Access Compliance Report

Public Rights-of-Way

(Curb Ramps)

Intersection ID: 42726	Main Street: CAMPION_CT	Cross Street: PICKEREL_LN	Location: E
ADA ID: 281014FE7FEA	Ramp Type: Perp	Initial Pass/Fail: Fail	Overall Compliance: No
Severity Score: 10			
Codes/Mitigation Info/Possible Solution		Field Measurements/Component Compliance

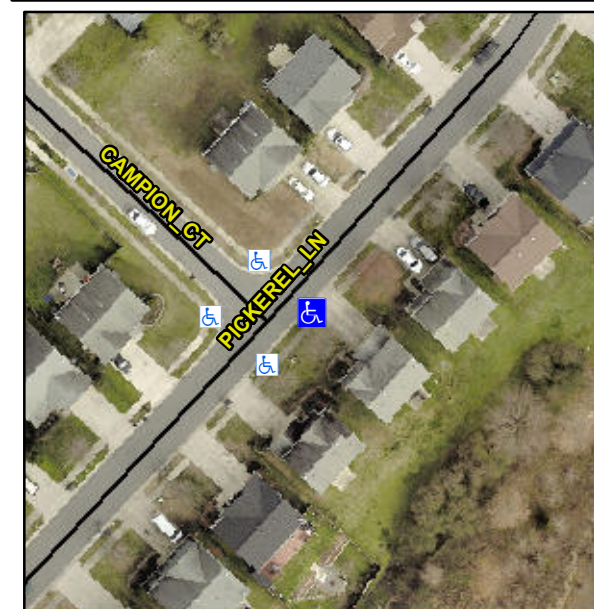
Not Found, R304.5.1

Compliance	Description	Data	Compliance	Description	Data
N/A	Ramp Length (in)	48.0	Yes	Ramp Slope (%)	5.0
No	Ramp Width (in)	47.0	Yes	Ramp XSlope (%)	2.4
N/A	Flare Type LT	N/A	N/A	Flare Type RT	N/A
N/A	Flare Slope LT (%)	N/A	N/A	Flare Slope RT (%)	N/A
N/A	Flare Traversable LT?	N/A	N/A	Flare Traversable RT?	N/A
N/A	Landing Length (in)	N/A	N/A	DWS Provided?	N/A
N/A	Landing Width (in)	N/A	N/A	DWS Contrast?	N/A
N/A	Landing Slope (%)	N/A	N/A	DWS Length (in)	N/A
N/A	Landing X Slope (%)	N/A	N/A	DWS Full Width?	N/A
N/A	Landing Curb? (Y/N)	N/A	N/A	DWS Offset (in)	N/A
N/A	Shared Landing?	N/A			
N/A	Gutter Ponding?	N/A	N/A	Gutter Slope (%)	N/A
N/A	Gutter Lip Ht (in)	N/A	N/A	Gutter X Slope (%)	N/A
N/A	Painted X Walk1?	No	N/A	Painted X Walk2?	N/A
	X Walk 1 Direction	To NW		X Walk 2 Direction	N/A
N/A	X Walk 1 Width (in)	N/A	N/A	X Walk 2 Width (in)	N/A
	X Walk 1 Slope (%)	6.5		X Walk 2 Slope (%)	N/A
	X Walk 1 X Slope (%)	3.2		X Walk 2 X Slope (%)	N/A

Remove & Replace Entire Ramp.
